# OTHELLO APARTMENTS

7339 43RD AVENUE SOUTH

DESIGN REVIEW RECOMMENDATION

09.26.17 | MUP # 3019543

## PROJECT USES AND ACTIVITIES

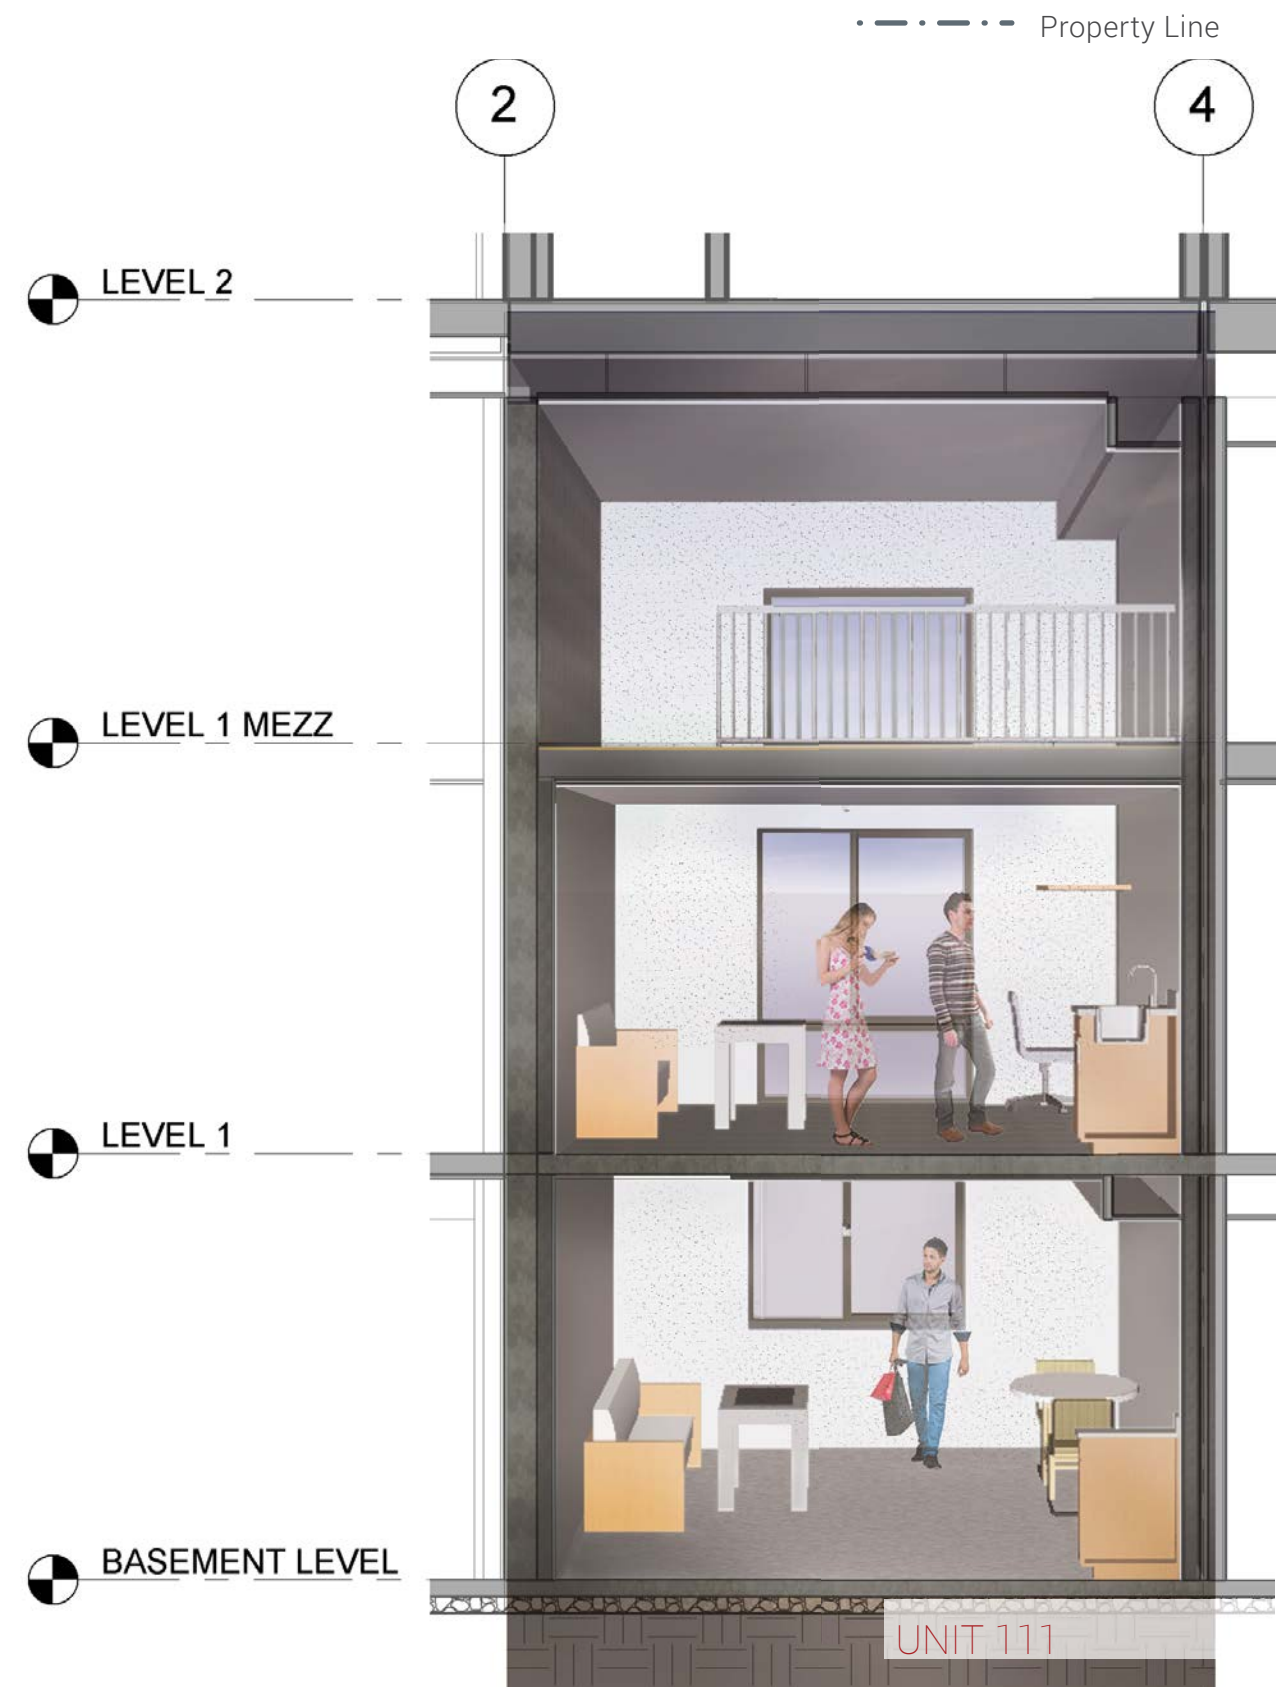
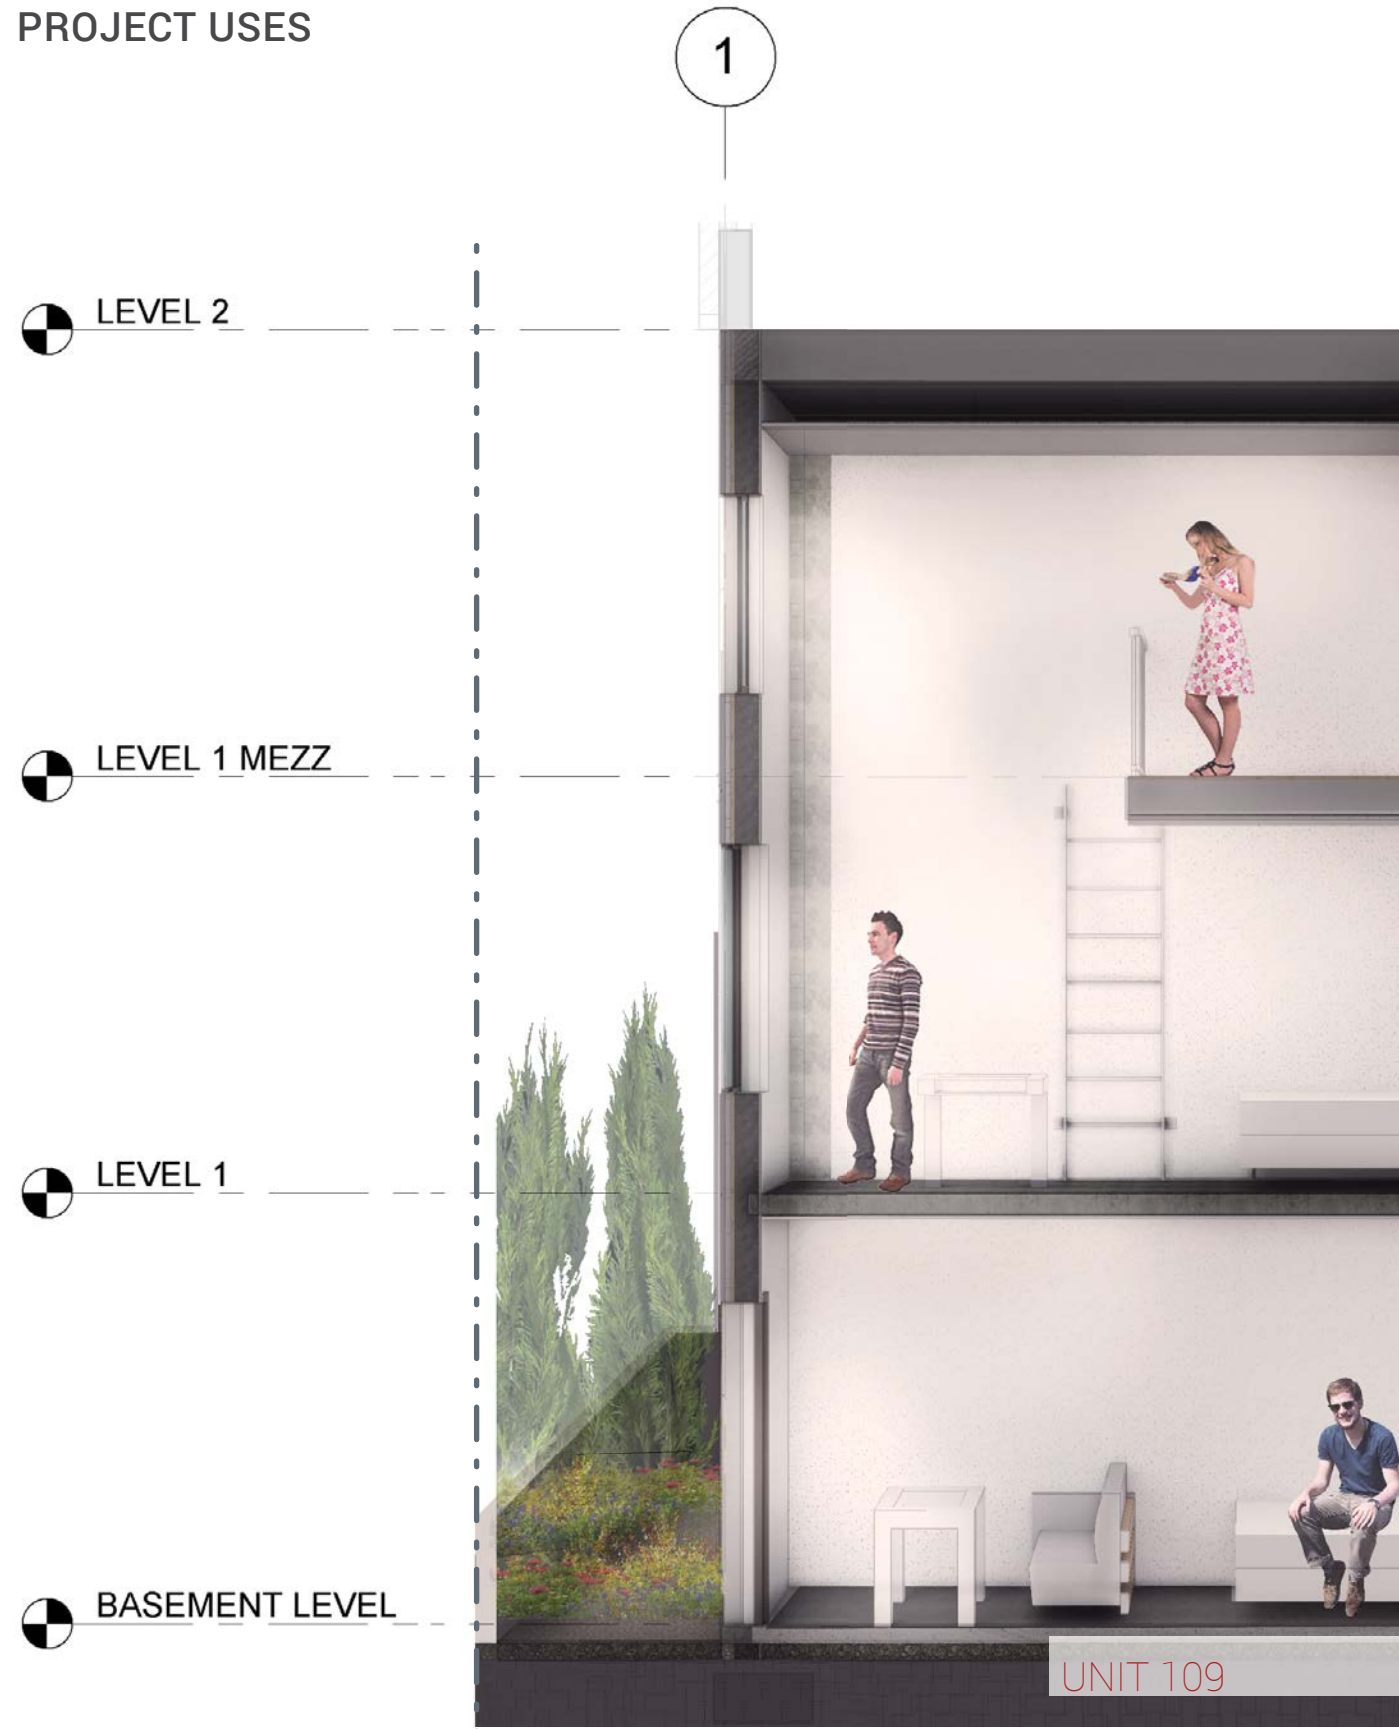
At recommendation the applicant should provide site sections through to the basements units and full floor plans to examine access to light and general livability.

**The basement units from the previous EDG design have been reduced to only 3 units not having direct access to light. Those units all have window wells and will receive incidental and ambient light from the neighboring facade.**

## COMMUNITY SPACES

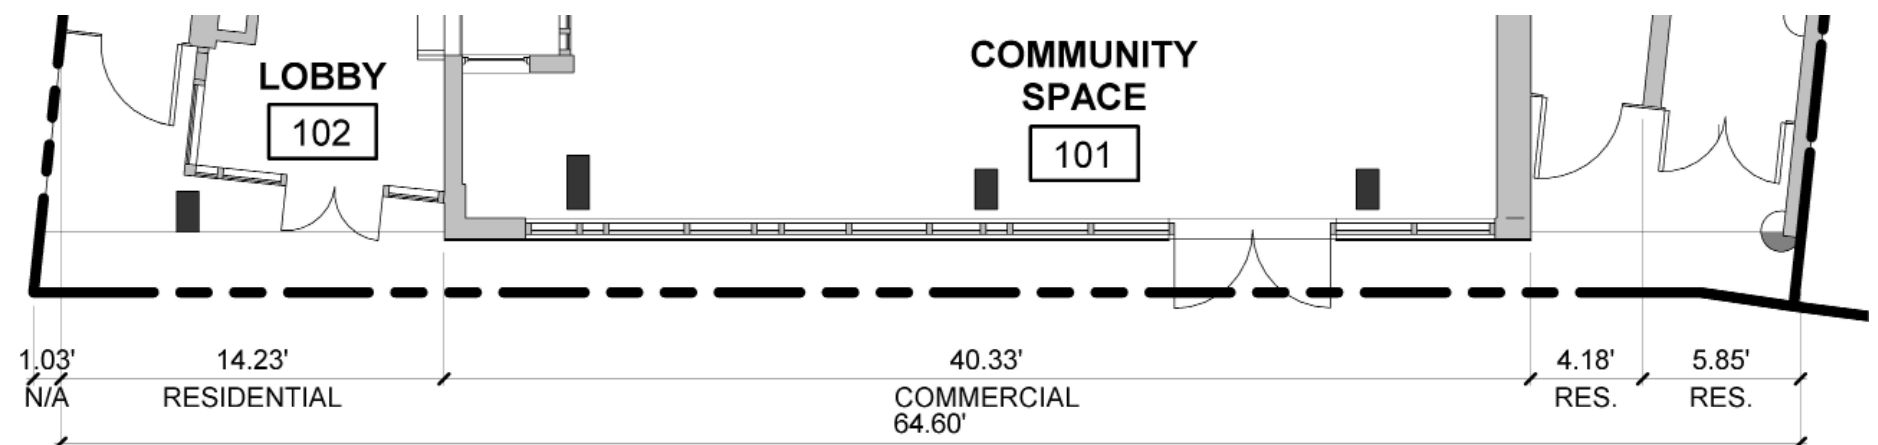
The Board was pleased with the large opening at the building's south façade. They were interested in the programming of amenity spaces and asked the applicant to provide detailed plans at recommendation.

**The amenity space in the south courtyard has been programmed to be a community space with access to the exterior and the interior community space. Amenity spaces have been added to the south courtyard, roof and to the east 1st floor facing the park.**

As an existing on-site natural area, the right of way reinforces the existing character of the abutting off-site park, providing a generous setback for a gracious entry forecourt along the street edge and a secondary public space for residents and pedestrians to interact. It allows the interior community space to spill out onto a framed patio and greenspace, serving as a "front porch" out toward Othello Park.
